## **AC-19-03 (Redwood Garage Standards Appeal)**

**Purpose:** Seeking clarification on the conditions associated with the Redwood Garage Alternative Compliance appeal approved on October 15, 2019.

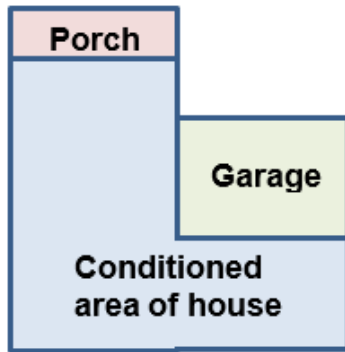
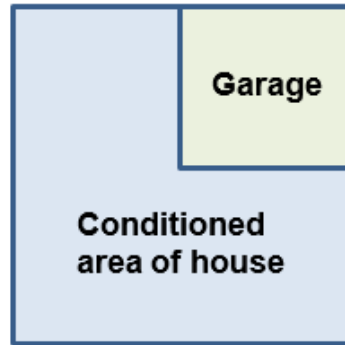
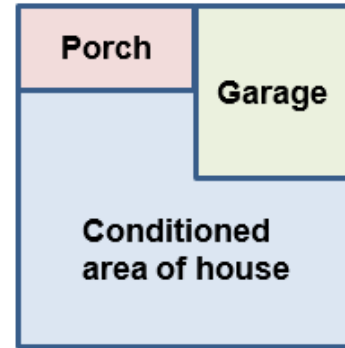
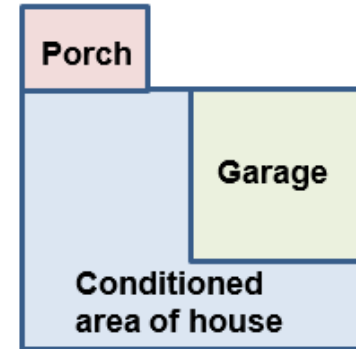
Per the approved condition, **all garages in the subdivision must be positioned behind (per code) or flush with the front most protrusion of the house.** Under this condition, a garage can either be built as follows:

**(A maximum of 50% of homes can look like Figure 2, 3 and 4. The remaining homes must meet current code.)**

In no case shall the garage be the front most protrusion of the home, but it may be flush on a maximum of 50% of the homes within the development. For the purposes of this condition, a front porch is considered a protrusion of the home.

**Figure 7:** Porch extends in front of the front façade of the house.

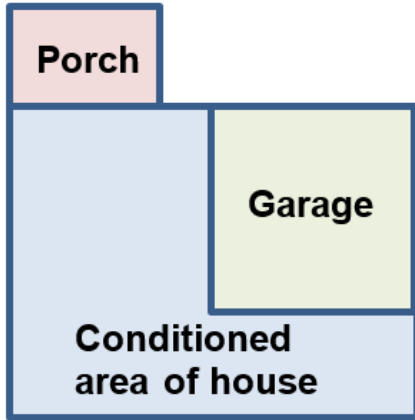
As currently written, condition 4 states that a porch “must extend in front of the front façade of the house”.

A front porch shall be required on a minimum of 50% of the homes. The front porch shall ~~extend in front of the front façade of the house and shall~~ be a minimum of 6 feet of clear space in all directions and shall have a minimum area of 60 square feet;

**Figure 8:** Porch is flush with the garage.

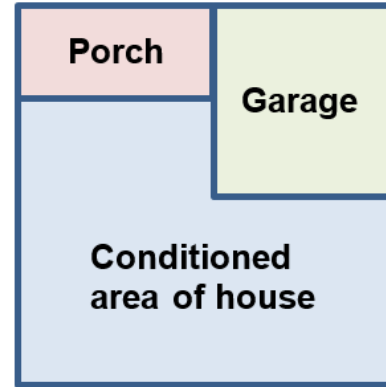
However, condition 3 allows the front porch to be flush with the garage and is not required to extend in front of the front façade of the house.
